STATE OF MAINE
DEPARTMENT OF TRANSPORTATION
16 STATE HOUSE STATION
AUGUSTA, MAINE 04333-0016

December 6, 2024
Subject: Puddle Dock Bridge #3107
State WIN: 025299.00
Location: **Albion**
Amendment No. 1

Standard Details

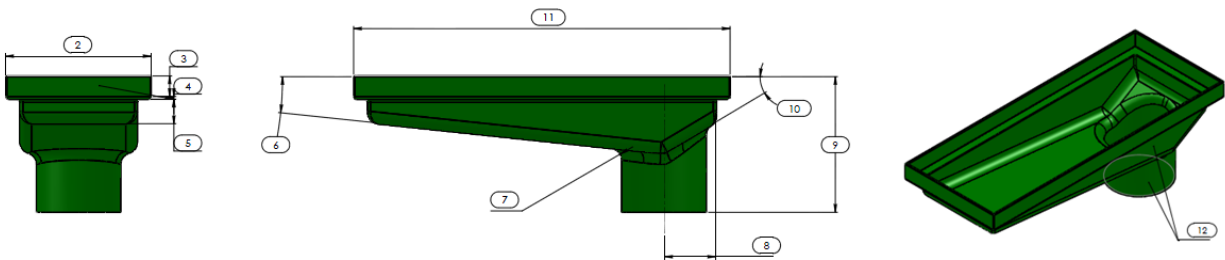
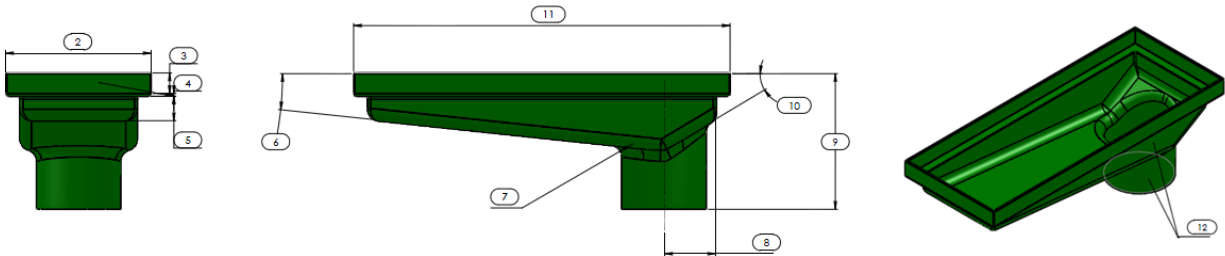
Please advise on the grate frame and downspout sizes for the "A1" FRP bridge drain scupper. Neither the drawing nor specification call out that particular size.

REMOVE Pages 103 to 117 SPECIAL PROVISION – SECTION 502 (Fiber Reinforced Polymer Bridge Drains) dated 8/30/24 and **REPLACE** with the attached revised SPECIAL PROVISION – SECTION 502 (Fiber Reinforced Polymer Bridge Drains) dated 12/2/24.

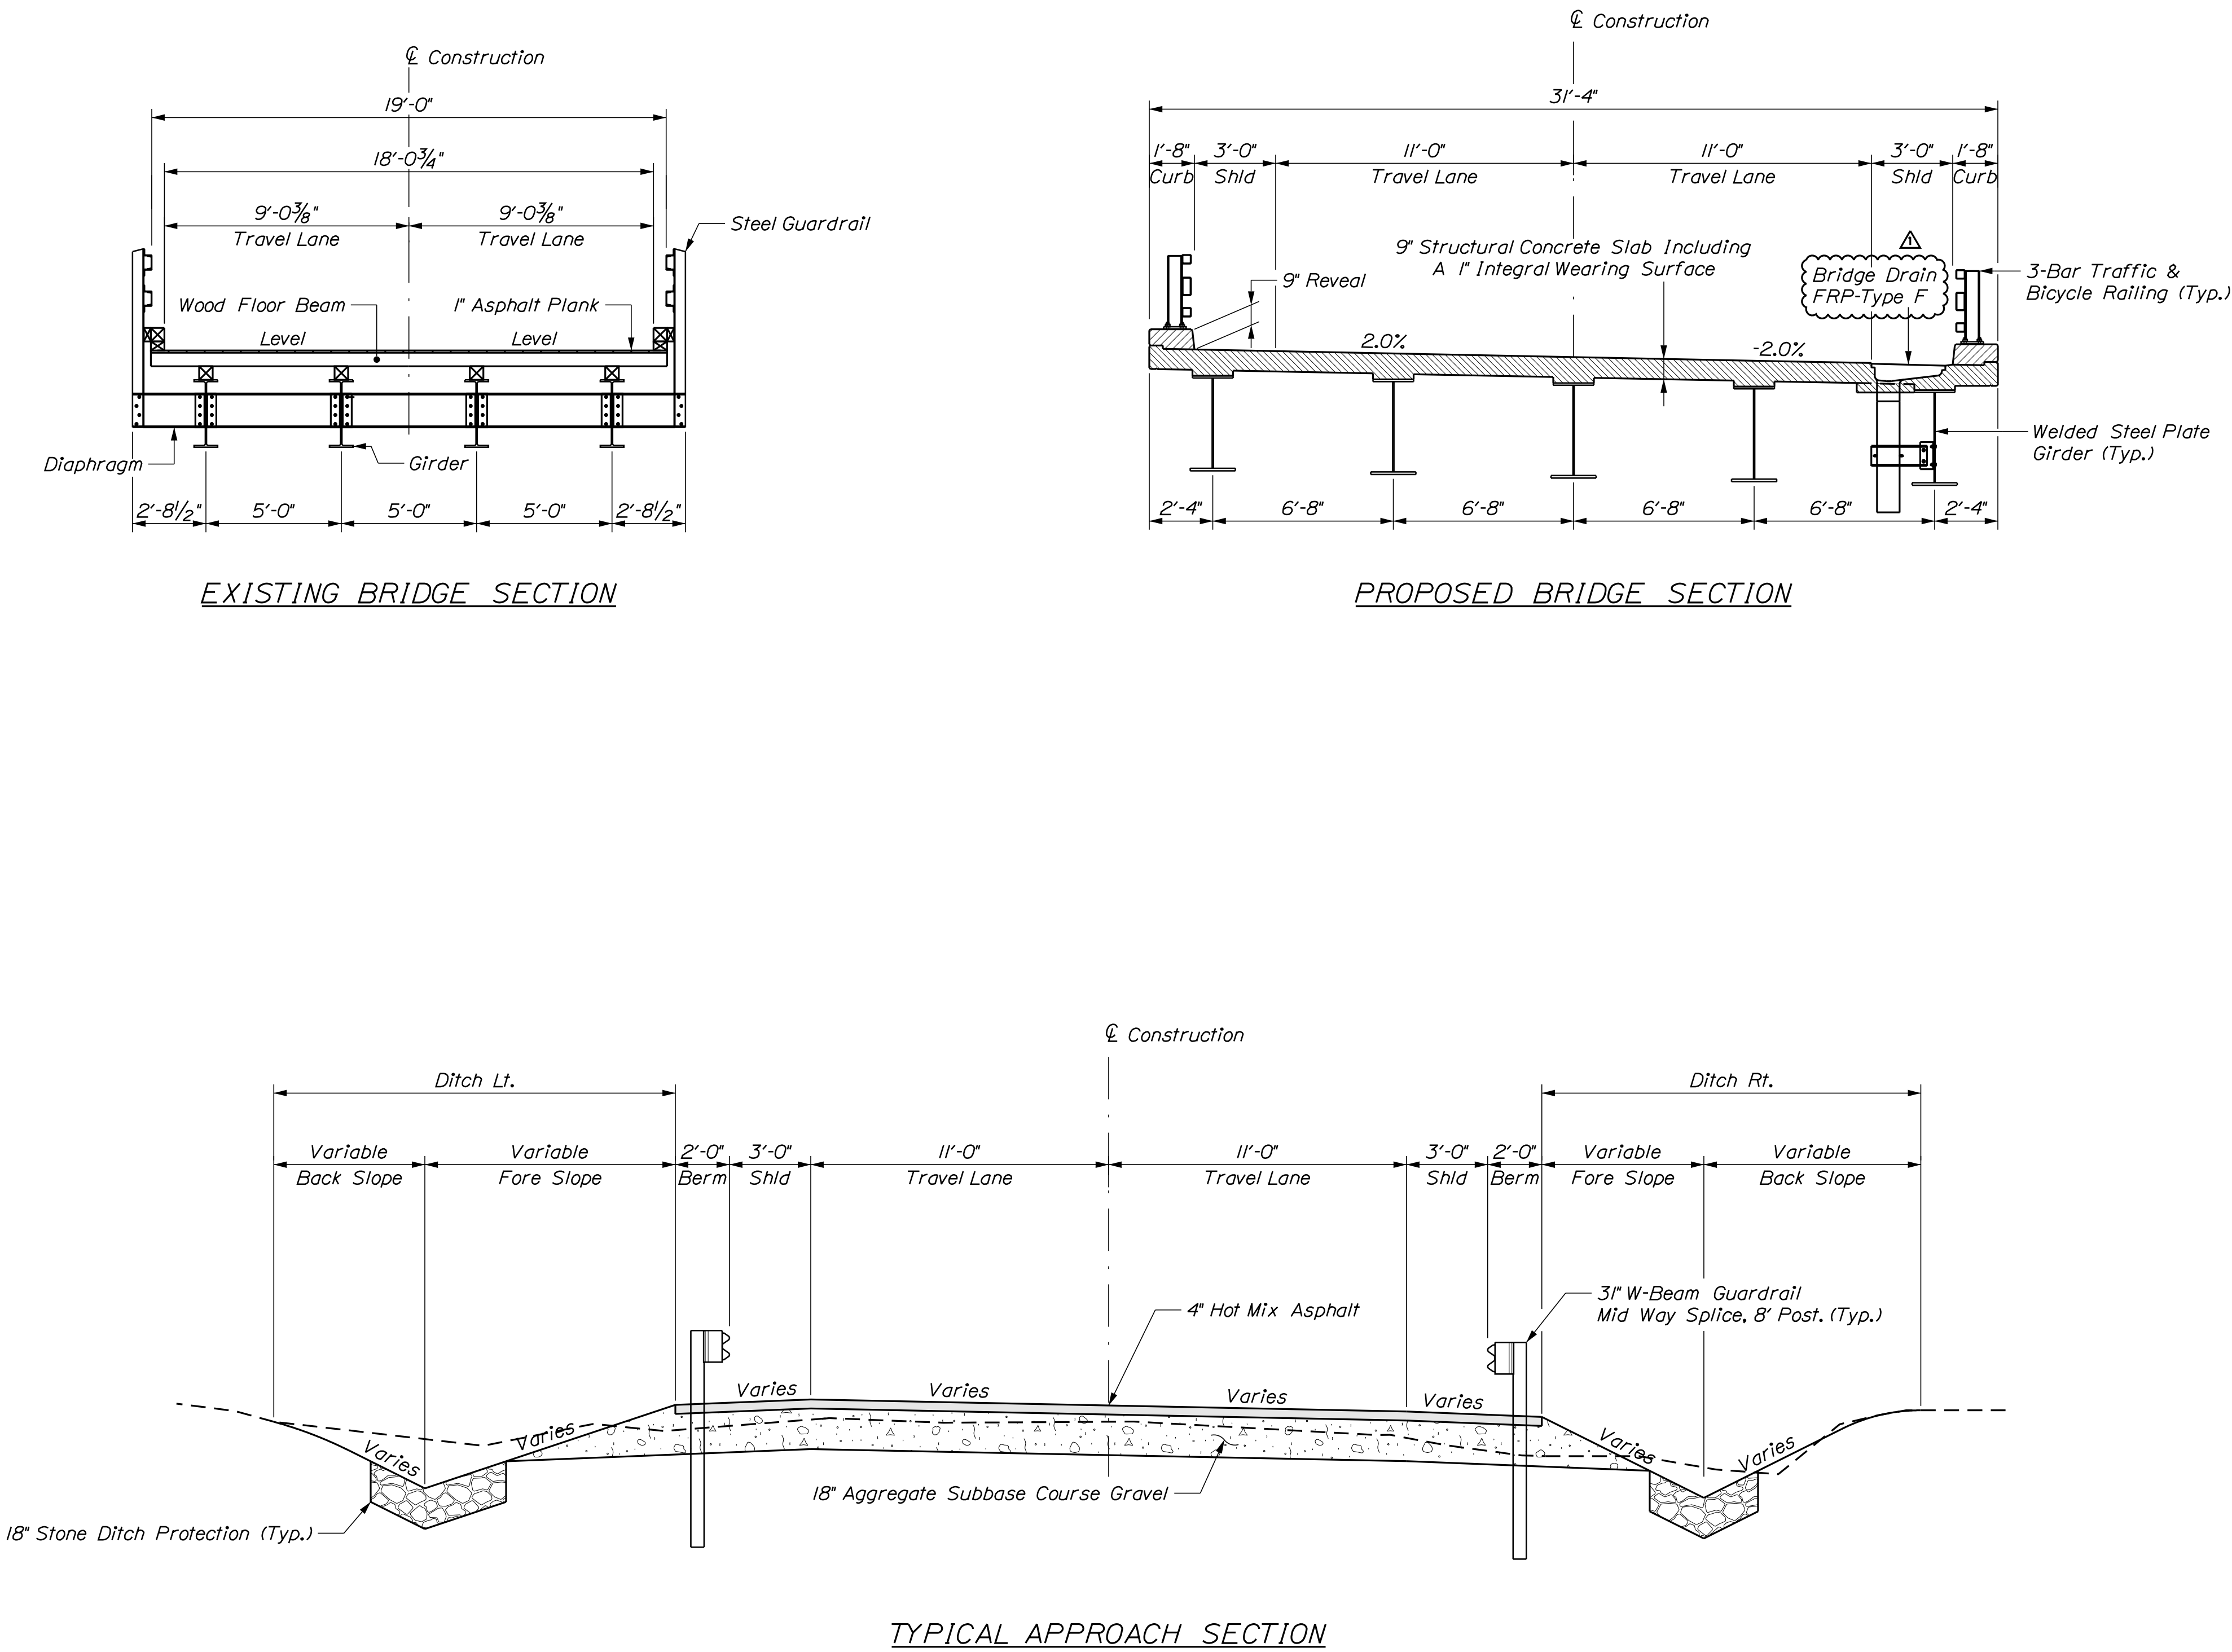
REMOVE from the plan set Sheet 7 TYPICAL SECTIONS dated 11/18/2024 and **REPLACE** with the attached revised Sheet 7 TYPICAL SECTIONS dated 12/3/2024

SUPERSTRUCTURE PLAN & REINFORCING

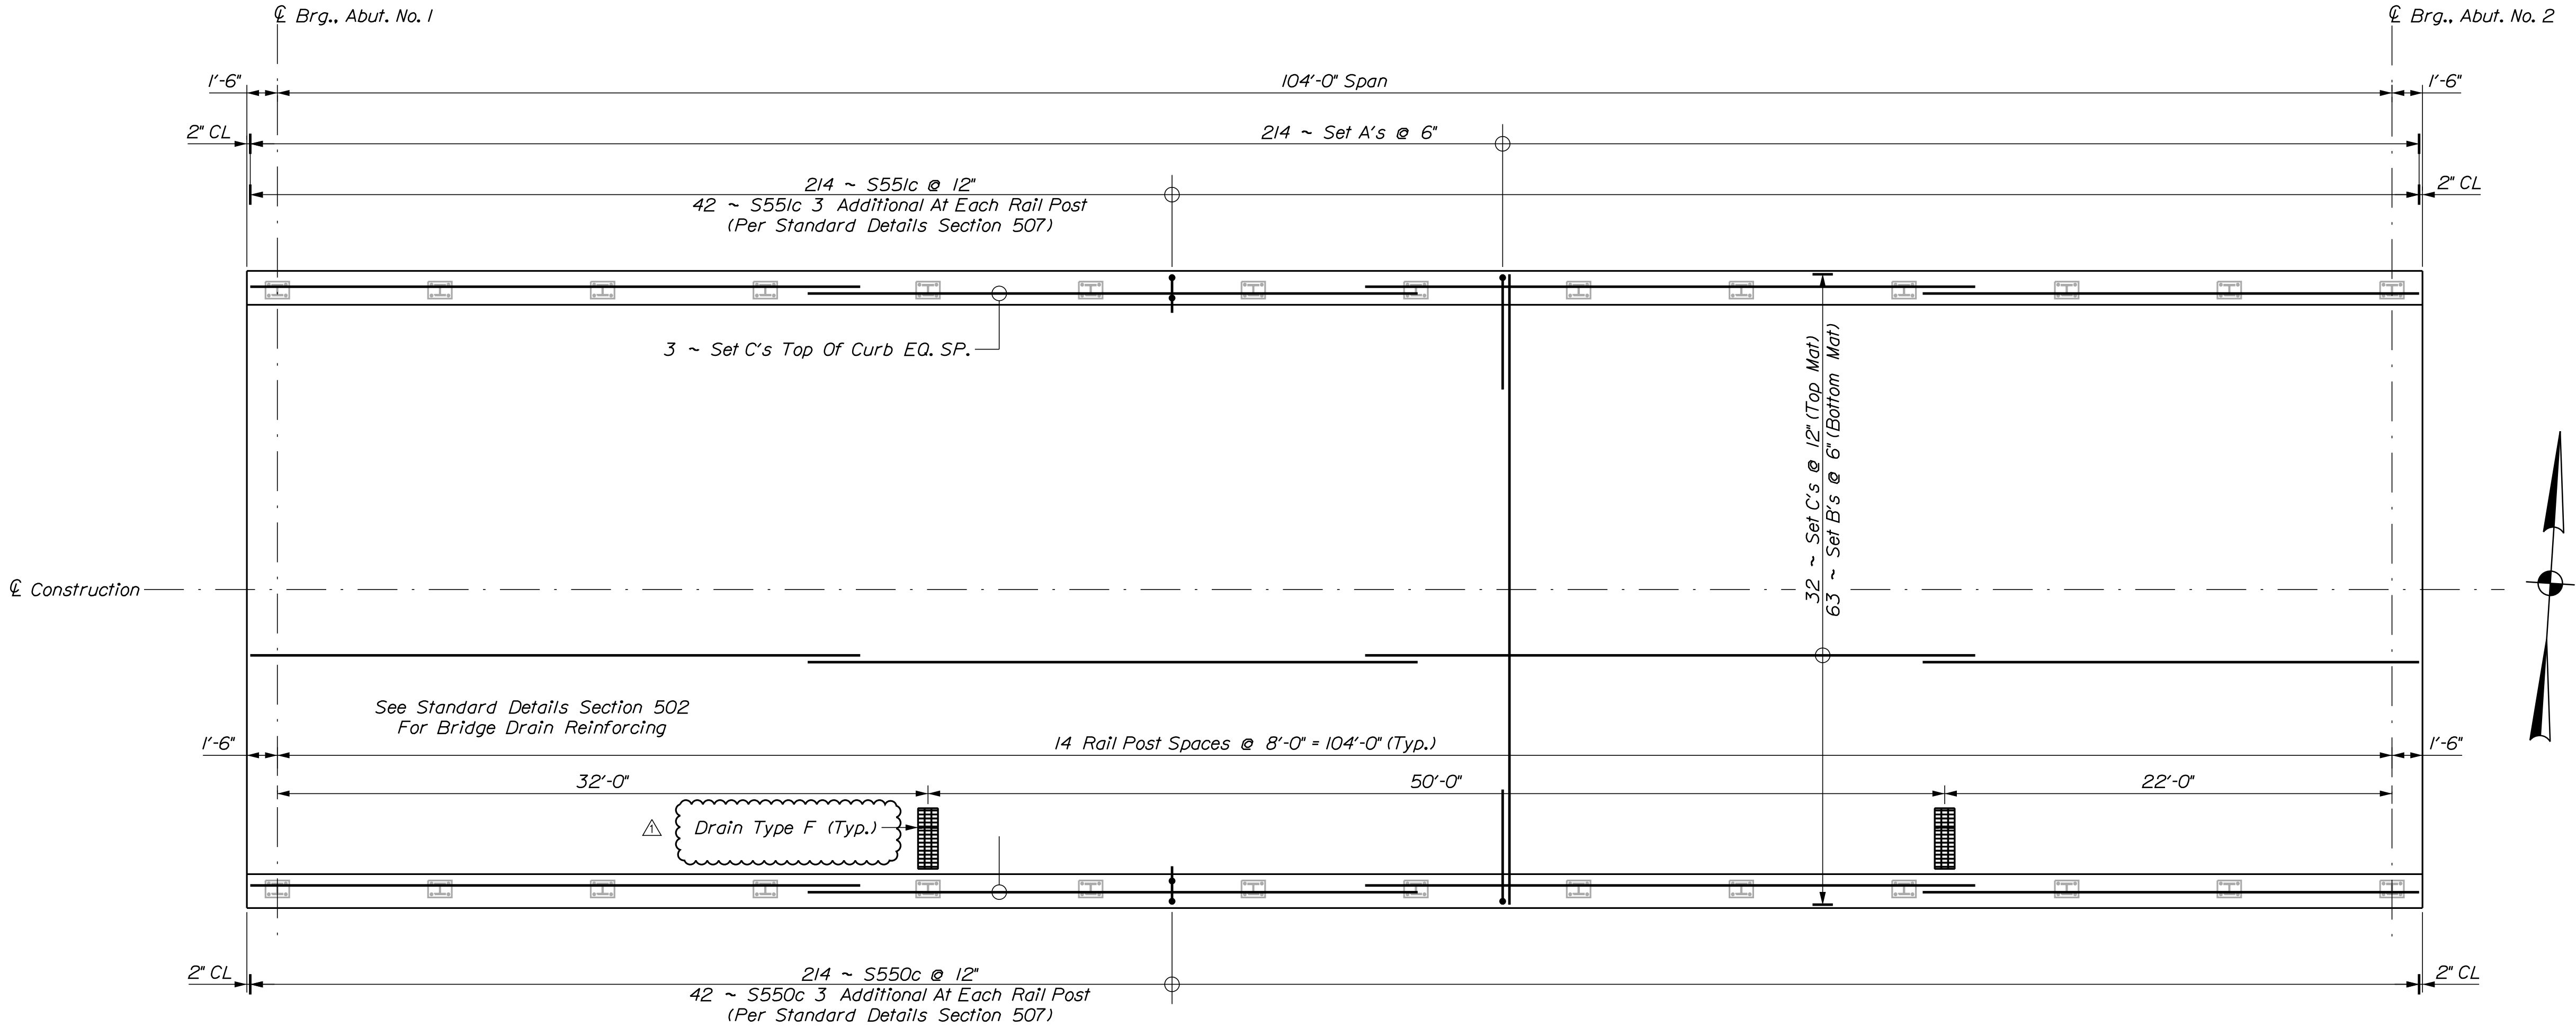
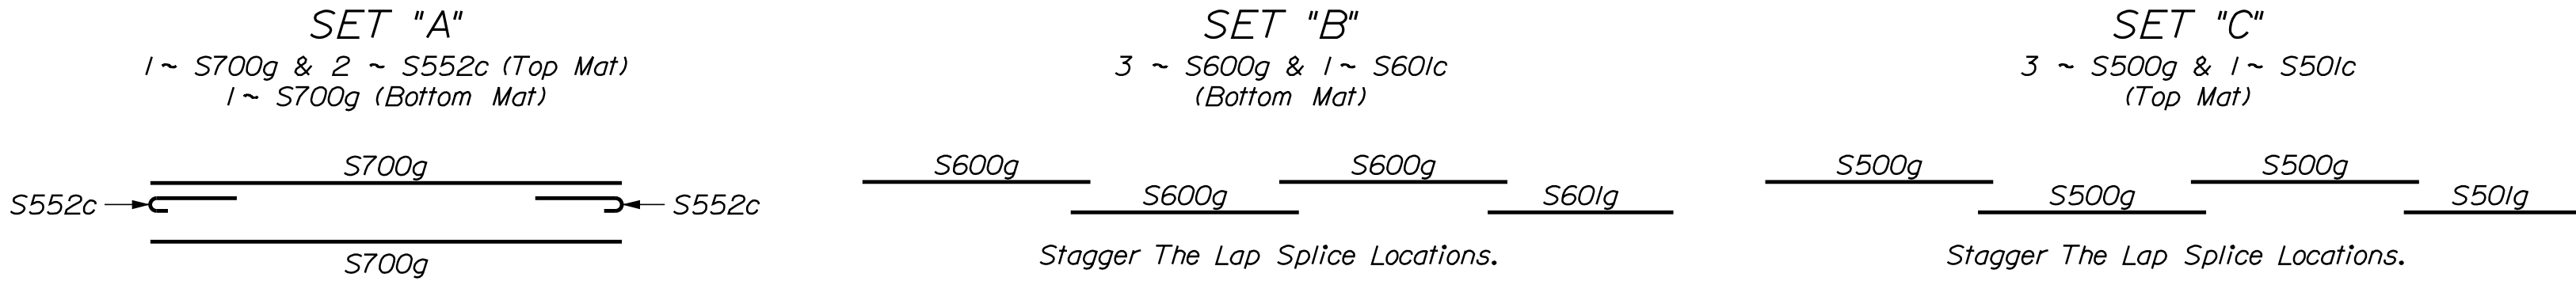
REMOVE from the plan set Sheet 28 SUPERSTRUCTURE PLAN & REINFORCING dated 11/18/2024 and **REPLACE** with the attached revised Sheet 28 SUPERSTRUCTURE PLAN & REINFORCING dated 12/3/2024
